Comments #211, #213, #182, #204

Chris DiMinico
MC Communications/PHY-SI LLC/Panduit
cdiminico@ieee.org

Figure 136D-4—QSFP-DD to 8xSFP28 cable assembly

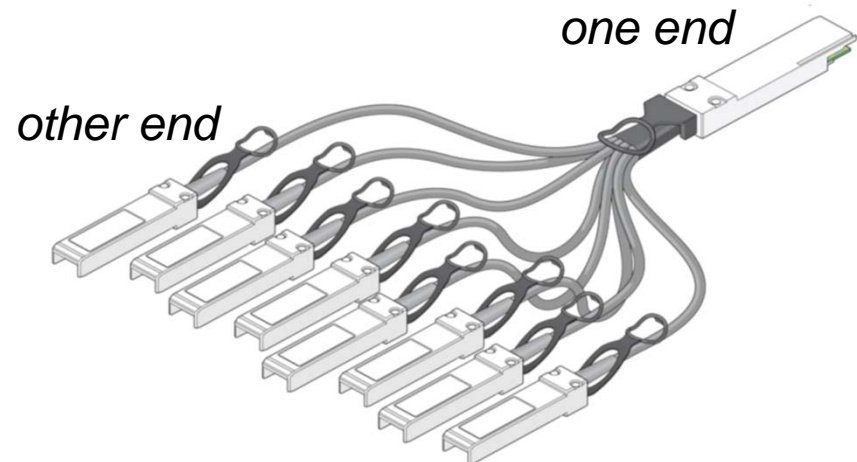
It is confusing to state the aggressors are in column two through four because there are separate columns for next and fext.

Change to "the crosstalk paths are from the aggressors listed horizontally to the victims listed vertically.

Add victim label to first column to support existing text. "the crosstalk paths are from the aggressors given in columns two through four to the victim given in the first column."

Delete text P174, L2, adopt text and Table 162-20 below with editorial license

The number of crosstalk paths of each MDI type are given in Table 162-20; the crosstalk paths are from the aggressors given in columns two through four to the victim given in the first column.
